ANADROMOUS WATERS CATALOG/ATLAS
CORRECTION FORM

Map: Tanana B-3

Water Body Number: 334-40-11000-2508

Nomination Number: 11-047

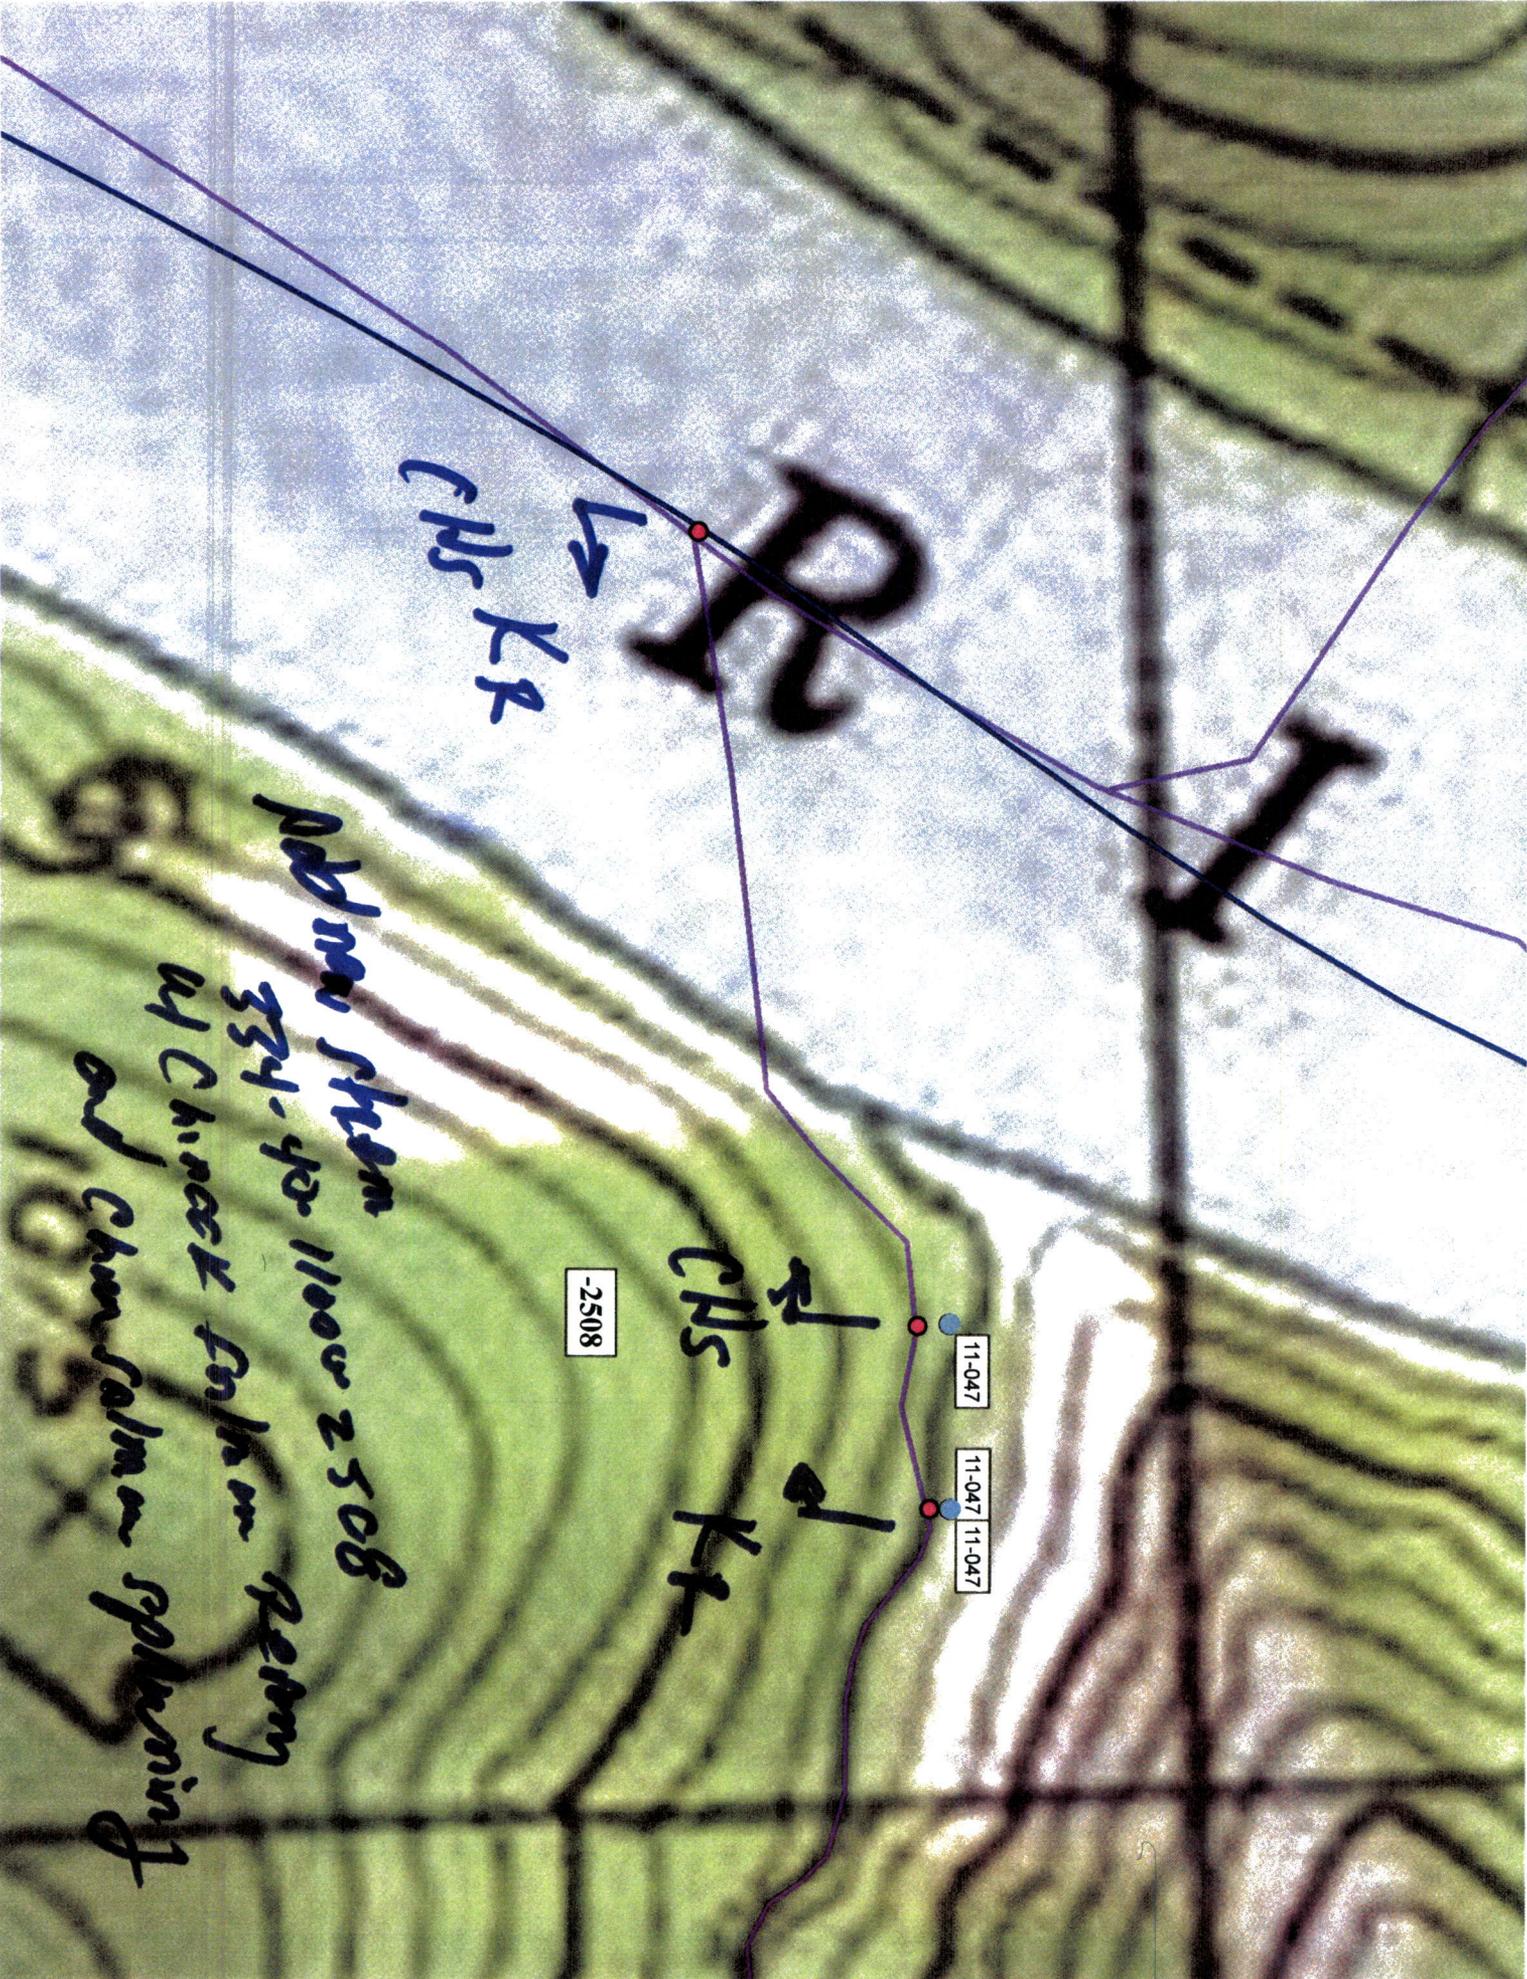
Describe Change(s): change chum salmon spawning to
 present after further review of nomination

J: Most look fine. I had questions about some of the CHP designations. See comments below for each creek in question.
